1636 AND 1637 TYPE TELEPHONE SET CONNECTING DIAGRAM

WESTERN ELECTRIC CO. INC. ENGINEER OF MANUFACTURE

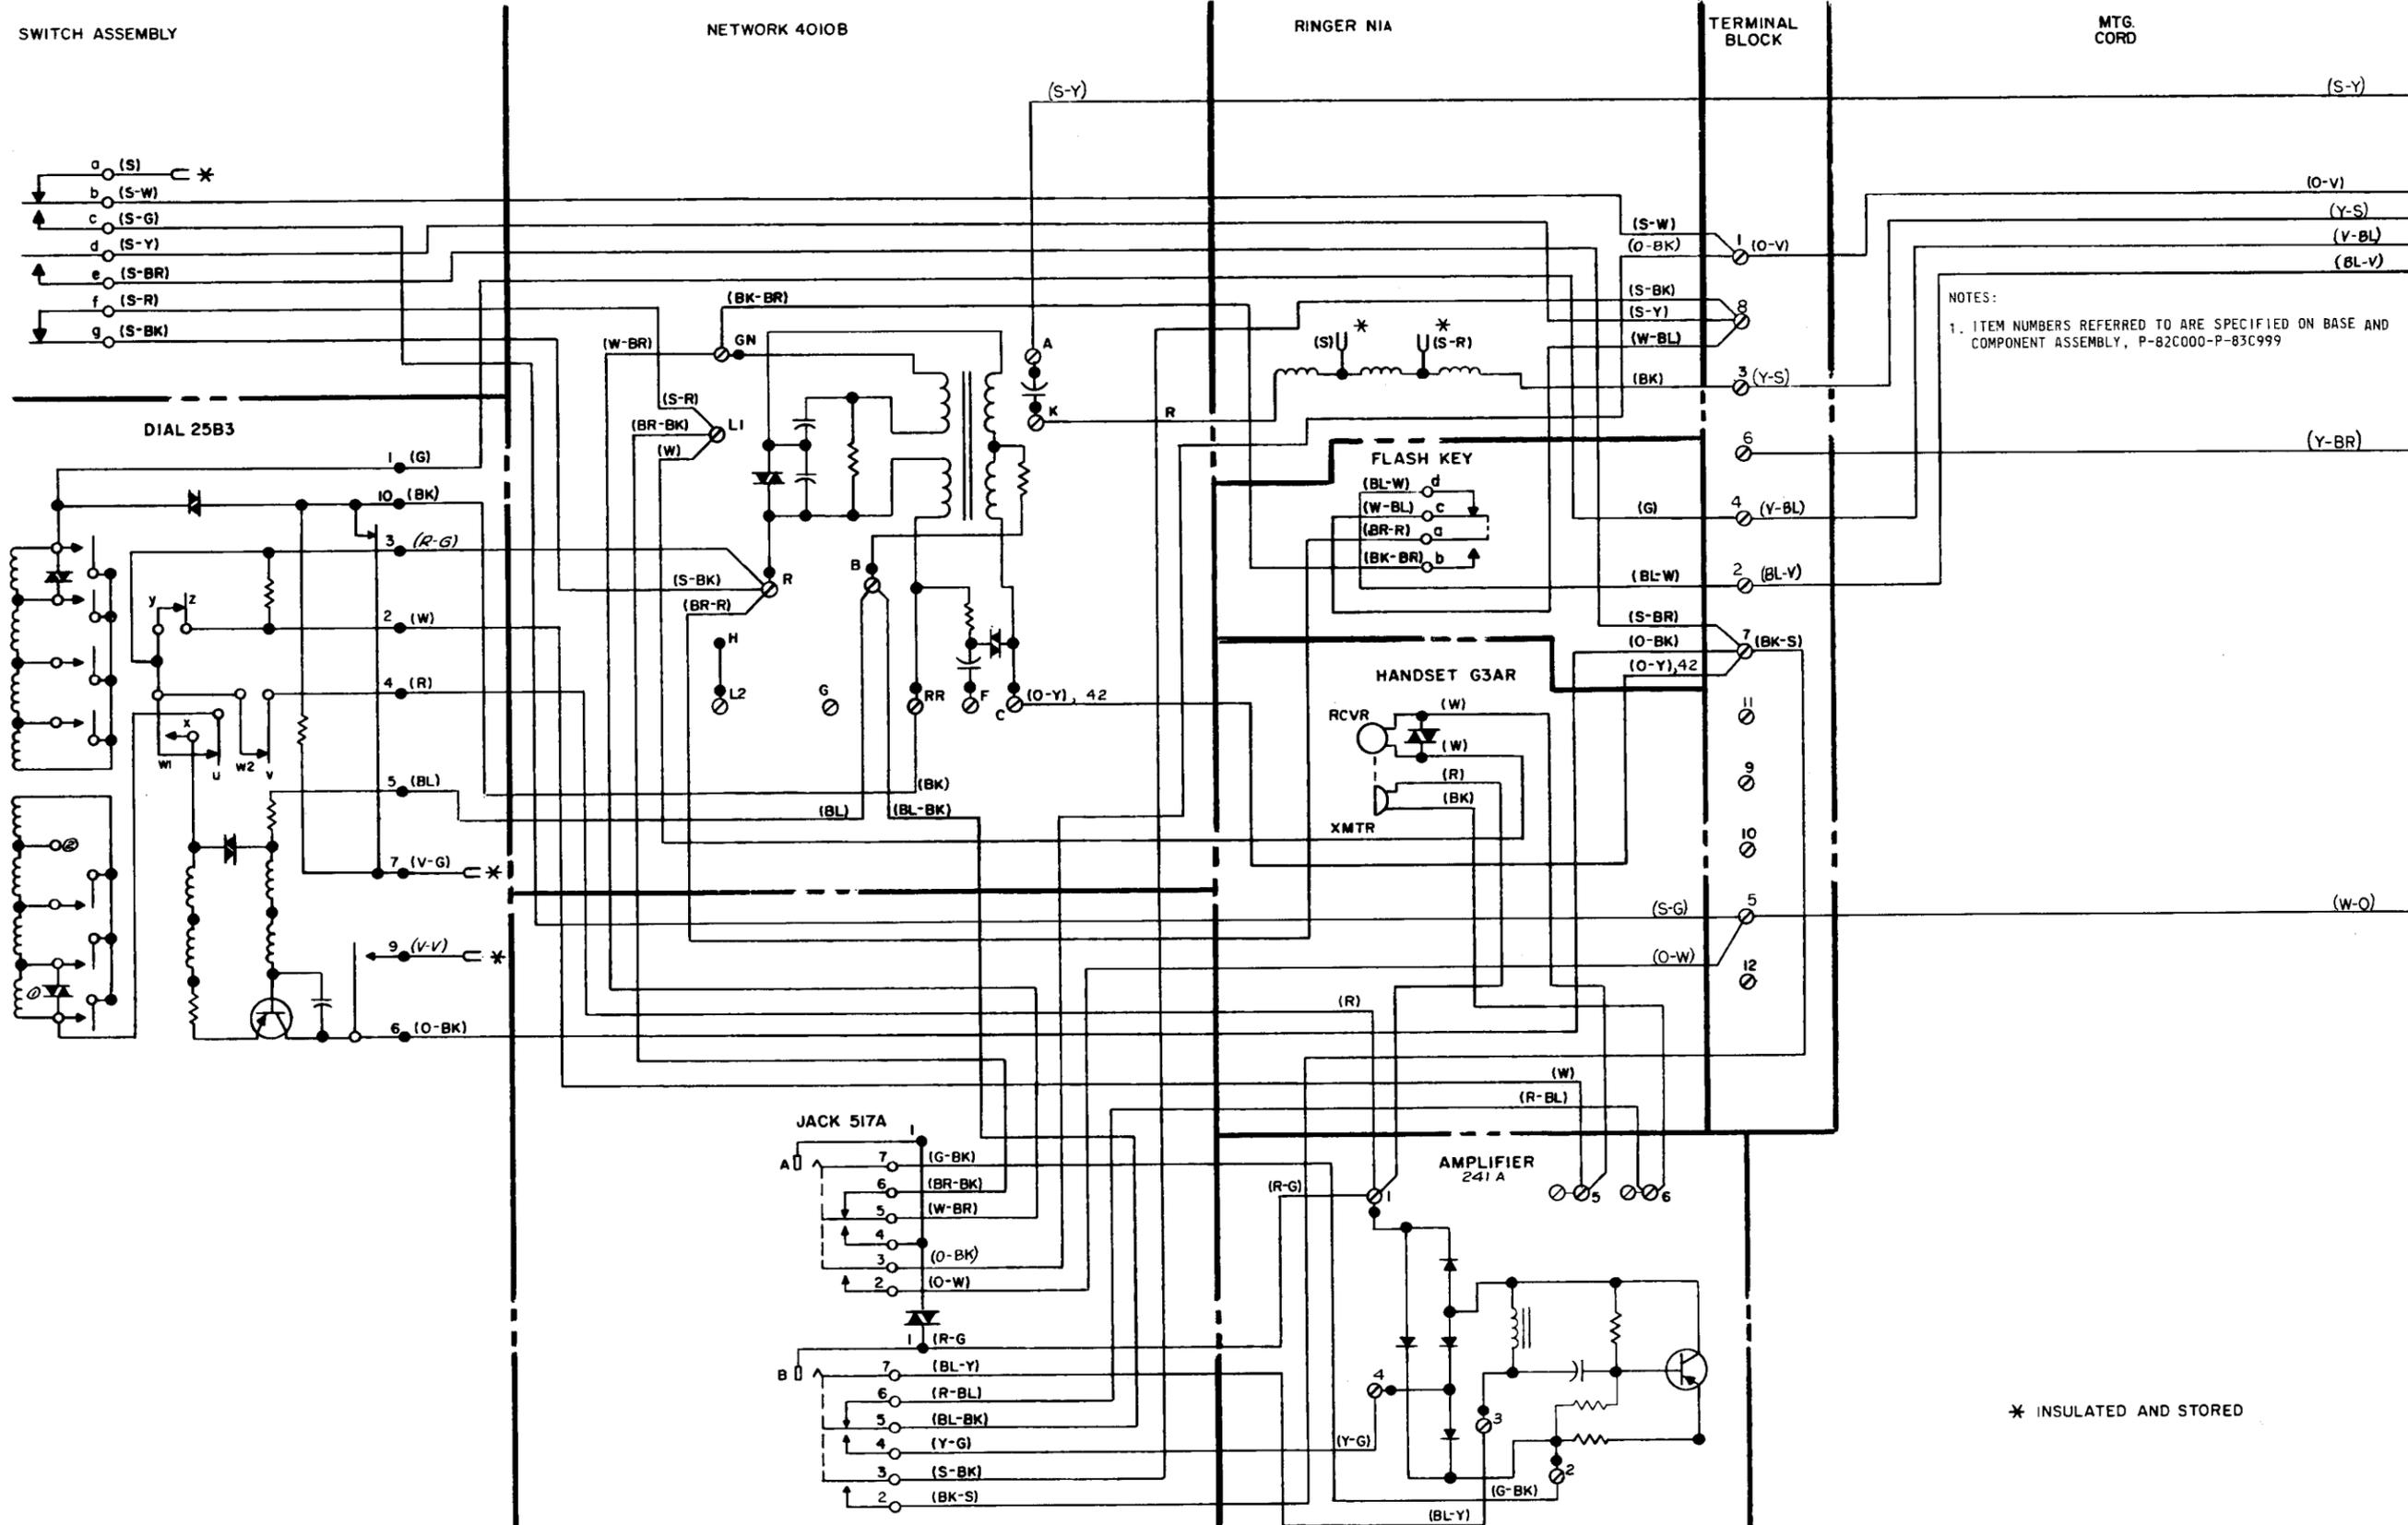
ADDED: NOTE 1 AND ASSOCIATED ITEM #2 DESIGNATION

CHANGED: VARIOUS CONNECTIONS TO AGREE WITH LATEST DESIGN; PRODUCT NOT AFFECTED

ADDED: "241 A" IN AMP SECT; MIDDLE RES IN AMP SECT

CHANGED: IN AMP SECT, SCR TERM DESIGS 4, 3, & 2 WERE 2, 4 & 3 RESP; SCR TERMS 5 & 6 WERE SINGLE TERMS

CHANGED: BK & R-G LEADS FROM 25B3 DIAL WERE BA-BK & Y-V RESP; O-BK LEAD FROM 517A JACK WAS V-O; BL-V & V-BL MTG CORD LEADS WERE R & G RESP

CHANGED: R-G & V-V DIAL LEADS WERE R-R & R-G RESP

ADDED: AT DIAL, VAR AT O

REMOVED: AT DIAL, SW CONT AT O
